Access Compliance Report

Public Rights-of-Way

Intersection ID: 16824	Main Street: IDLEWILD_RD	Cross Street: LYNMONT_DR	Location: SE
ADA ID: 177B3B8F0934	Ramp Type: PerpDiag	Initial Pass/Fail: Fail	Overall Compliance: No
		Severity Score: 37.5

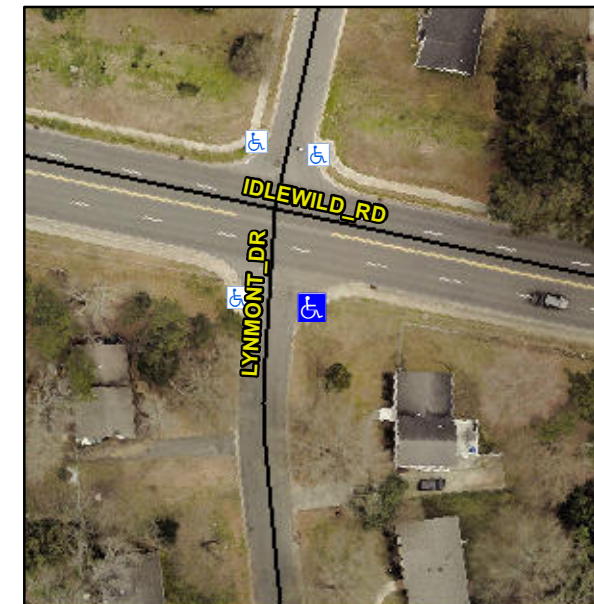
R304.2.2, R304.5.3

Compliance	Description	Data	Compliance	Description	Data
N/A	Ramp Length (in)	60.0	No	Ramp Slope (%)	9.9
Yes	Ramp Width (in)	48.0	No	Ramp XSlope (%)	9.9
N/A	Flare Type LT	N/A	N/A	Flare Type RT	N/A
N/A	Flare Slope LT (%)	N/A	N/A	Flare Slope RT (%)	N/A
N/A	Flare Traversable LT?	N/A	N/A	Flare Traversable RT?	N/A
N/A	Landing Length (in)	N/A	N/A	DWS Provided?	N/A
N/A	Landing Width (in)	N/A	N/A	DWS Contrast?	N/A
N/A	Landing Slope (%)	N/A	N/A	DWS Length (in)	N/A
N/A	Landing X Slope (%)	N/A	N/A	DWS Full Width?	N/A
N/A	Landing Curb? (Y/N)	N/A	N/A	DWS Offset (in)	N/A
N/A	Shared Landing?	N/A			
N/A	Gutter Ponding?	N/A	N/A	Gutter Slope (%)	N/A
N/A	Gutter Lip Ht (in)	1.0	N/A	Gutter X Slope (%)	N/A
N/A	Painted X Walk1?	No	N/A	Painted X Walk2?	No
	X Walk 1 Direction	To NE		X Walk 2 Direction	To W
N/A	X Walk 1 Width (in)	N/A	N/A	X Walk 2 Width (in)	N/A
	X Walk 1 Slope (%)	9.4		X Walk 2 Slope (%)	0.1
	X Walk 1 X Slope (%)	1.3		X Walk 2 X Slope (%)	8.1

Remove & Replace Curb Ramp With Two New Directional Ramps or Equivalent.
